Access Compliance Report

Public Rights-of-Way

Intersection ID: 10038891	Main Street: STIRLINGSHIRE_CT	Cross Street: N/A	Location: SE
ADA ID: 023D3C76FA10	Ramp Type: Perp	Initial Pass/Fail: Pass	Overall Compliance: No
Codes/Mitigation Info/Possible Solution		Field Measurements/Component Compliance	
Severity Score: 0.25

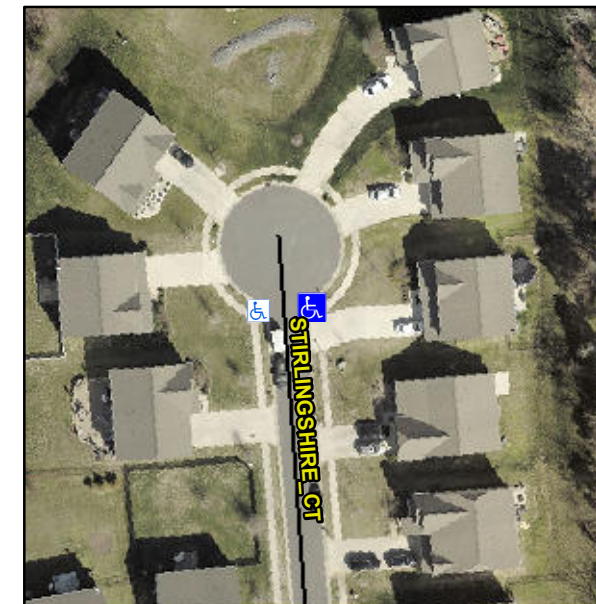
R304.5.3, R304.2.2-Perp, R304.3.2-Para

Compliance	Description	Data	Compliance	Description	Data
N/A	Ramp Length (in)	46.0	Yes	Ramp Slope (%)	6.7
Yes	Ramp Width (in)	48.0	No	Ramp XSlope (%)	2.5
N/A	Flare Type LT	Sloped	N/A	Flare Type RT	N/A
N/A	Flare Slope LT (%)	2.5	Yes	Flare Slope RT (%)	4.2
N/A	Flare Traversable LT?	Yes	N/A	Flare Traversable RT?	Yes
Yes	Landing Length (in)	48.0	Yes	DWS Provided?	Yes
Yes	Landing Width (in)	48.0	Yes	DWS Contrast?	Yes
No	Landing Slope (%)	3.9	Yes	DWS Length (in)	24.0
Yes	Landing X Slope (%)	1.6	Yes	DWS Full Width?	Yes
N/A	Landing Curb? (Y/N)	No	Yes	DWS Offset (in)	2.0
N/A	Shared Landing?	No			
Yes	Gutter Ponding?	No	Yes	Gutter Slope (%)	2.6
Yes	Gutter Lip Ht (in)	0.0	Yes	Gutter X Slope (%)	1.1
N/A	Painted X Walk1?	No	N/A	Painted X Walk2?	N/A
	X Walk 1 Direction	To W		X Walk 2 Direction	N/A
N/A	X Walk 1 Width (in)	N/A	N/A	X Walk 2 Width (in)	N/A
	X Walk 1 Slope (%)	4.9		X Walk 2 Slope (%)	N/A
	X Walk 1 X Slope (%)	1.1		X Walk 2 X Slope (%)	N/A

Remove & Replace Entire Ramp.
